Design Review Recommendation

April 16, 2015
DPD Project #3017306
7520 35th Avenue Ave SW
Seattle, Washington

DPD PROJECT #3017306 | DPD PERMIT #TBD | 7520 35TH AVENUE SW | DESIGN REVIEW SUBMITTAL | APR.16.2015

Blade sign examples

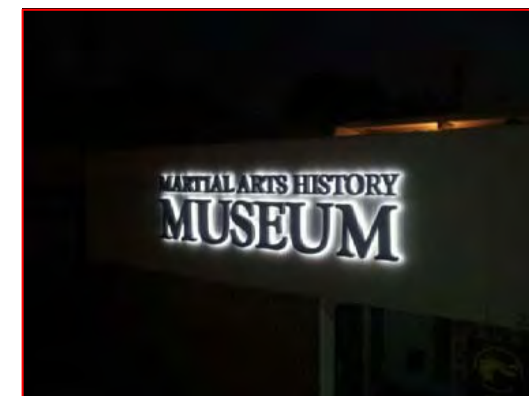
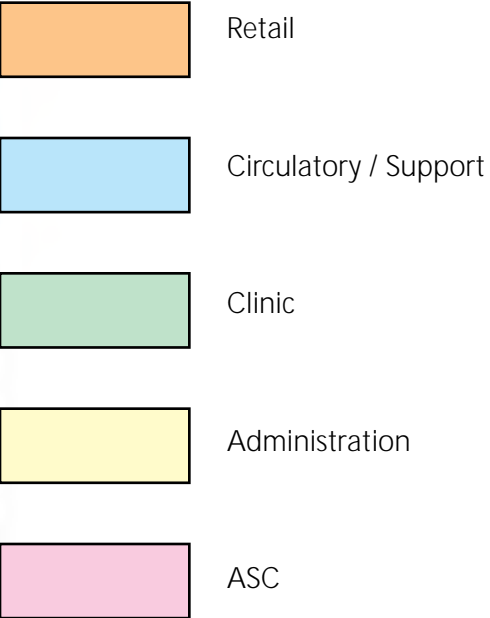
At the Recommendation meeting, the Board expects to review a conceptual signage plan that is designed to be consistent with the architectural concept and responsive to the pedestrian experience. The Board voiced concern with the proposed horizontal signage at the parapet level and encouraged a design that incorporates vertical and street-level (canopy) signage. **(DC4.B)**

As the project is not speculatively developed and is being constructed and occupied by the owner/occupants, developing signage has been carefully considered and integrated into the overall building design. The use of the vertical fin element at the building’s entry provides a unique identity to the building and is a natural opportunity to provide primary signage. The “Clearview” letters may be raised and illuminated by appropriate up-lights or may be softly backlit channel letters. The orientation of this primary signage reflects the desire to provide visibility to north bound traveling vehicles (and pedestrians) allowing easy identification of the building location for visitors that are anticipated to arrive largely from the south. Additional signage includes blade signs at street level awnings and overhangs or both the optical/eyewear retail space, address at main entry, and for the north retail space. Lastly, we have allowed for the owner’s trademark logo as a small square sign located on the northwest corner of the building’s parapet.

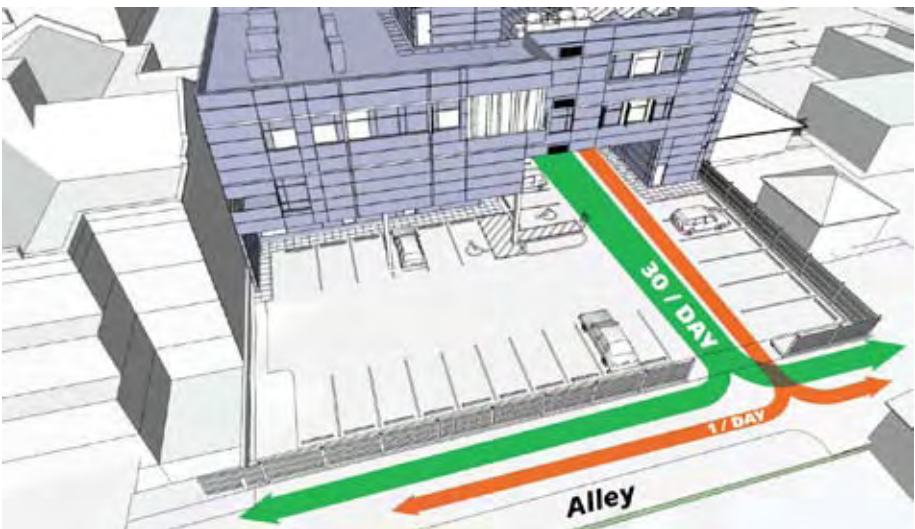
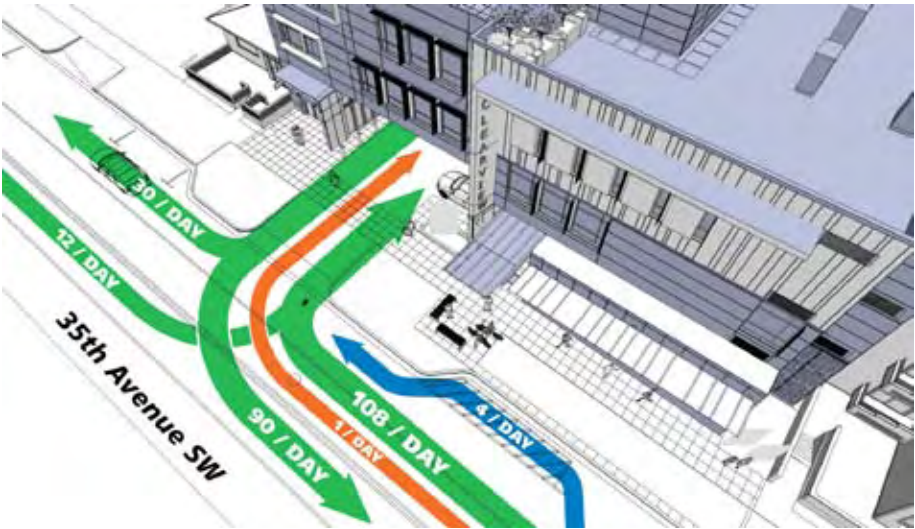
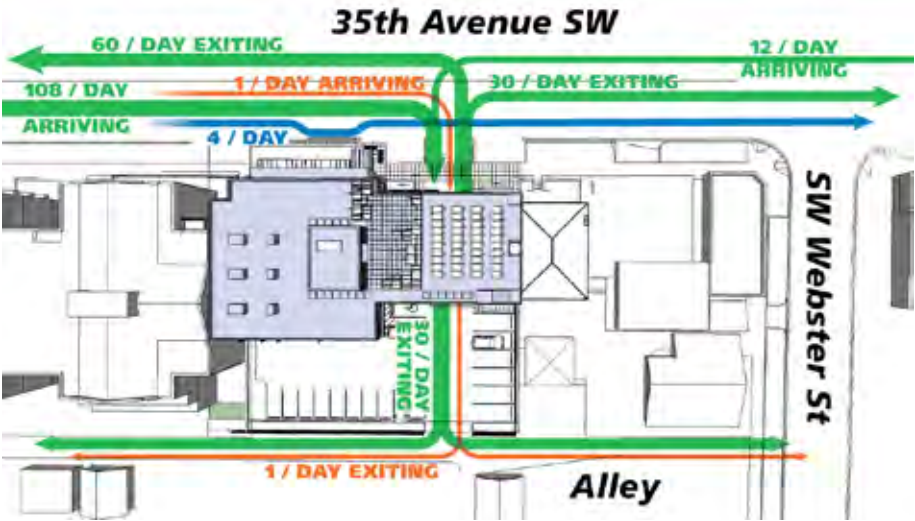
The Board indicated a willingness to entertain this requested departure, provided that the design concept includes a parking design with **access/circulation that better engages the 35th Avenue Southwest street-level frontage and screens the visual impacts of parking**. The applicant will need to provide more information (two and three dimensional diagrams, etc.) regarding **potential access/circulation options**; demonstrate how the requested departure would assist in **maximizing the use while engaging the 35th Avenue Southwest streetscape**; demonstrate how **protections for pedestrians** (traffic calming methods) will addressed and provide **feedback from SDOT/DPD staff** (Land Use Planner, Transportation Planner). The Board suggested that one potential option would be to establish a one-way traffic pattern or a right-in/right-out configuration for the 35th Avenue Southwest access. The Board also mentioned that a **load/unload parking zone** along 35th Avenue Southwest for emergency and drop-off/pick-up options should also be explored.

Response:
As indicated from the inception of this project, the need for access from 35th avenue and from an improved alley is essential to the building's use. The current design includes a variety of adjustments and improvements to the plans presented in the Second EDG presentation. Options for alternative circulation have been explored (see following sheet) and a preferred arrangement identified that addresses the Boards requests as follows:

2) “potential access/circulation options”; several alternatives have been explored as follows: (see diagrams next page)

- Option #1 - Two-Way Access (Preferred):** via existing 35th Ave. curb cut with screened parking on one side and inclusion of north retail space; compatible with SDOT SIP 30% approval.
- Option #2 - One-Way Access:** via existing 35th Ave. curb cut with screened parking on one side and inclusion of north retail space.
- Option #3 - Right Turn Only:** Two-way access via existing 35th Ave. curb cut on one side and inclusion of north retail space. Entry and exit restricted to right turn in and right turn out only traffic flow.
